Access Compliance Report Public Rights-of-Way (Curb Ramps)

Main Street: E_CHAPMAN_AVE		Cross Street: RANCHO_SANTIAGO_BLVD		Location:	SE
ADA ID: RPAT210929110134	Ramp Type: Type 4 - Parallel	Initial Pass/Fail: Fail	Overall Compliance: No	Severity Score:	15
Codes/Mitigation Info/Possible Solution			Field Measurements/Component Compliance

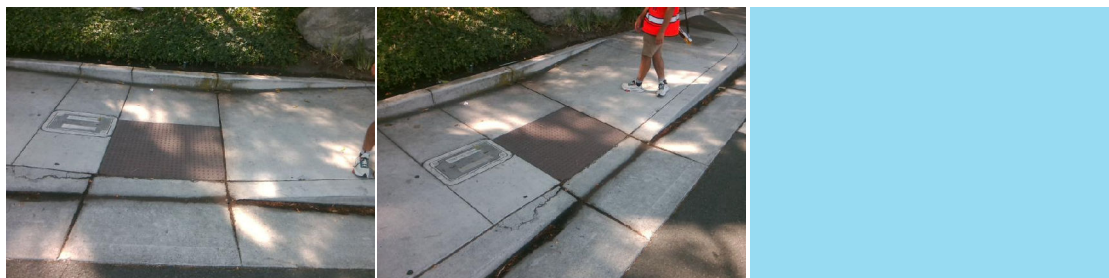
Compliance	Description	Data	Compliance	Description	Data
N/A	Ramp Length LT (in)	28	N/A	Ramp Length RT (in)	86
Yes	Ramp Width LT (in)	78	Yes	Ramp Width RT (in)	80
No	Ramp Run Slope LT (%)	9.4	Yes	Ramp Run Slope RT (%)	7
Yes	Ramp Cross Slope LT (%)	0.1	Yes	Ramp Cross Slope RT (%)	0.5
N/A	Landing Present	N/A	N/A	DWS Provided	N/A
N/A	Landing Length (in)	N/A	N/A	DWS Contrast	N/A
N/A	Landing Width (in)	N/A	N/A	DWS Length (in)	N/A
N/A	Landing Run Slope (%)	N/A	N/A	DWS Full Width	N/A
N/A	Landing Cross Slope (%)	N/A		DWS Offset Type	N/A
N/A	Landing Movement Obstructed?	N/A	N/A	DWS Offset Left (in)	N/A
	Landing Movement Type	N/A	N/A	DWS Offset Right (in)	N/A
N/A	Landing Shared	N/A			
N/A	Clear Space	N/A			
N/A	Clear Space To Crosswalk (in)	N/A			
N/A	Marked Crosswalk 1	Yes	N/A	Marked Crosswalk 2	N/A
	Crossing 1 Direction	N		Crossing 2 Direction	N/A
	Marked Crosswalk 1 Width (in)	120		Marked Crosswalk 2 Width (in)	N/A

Remove & Replace Entire Ramp.

R304.3.2, STD 1115
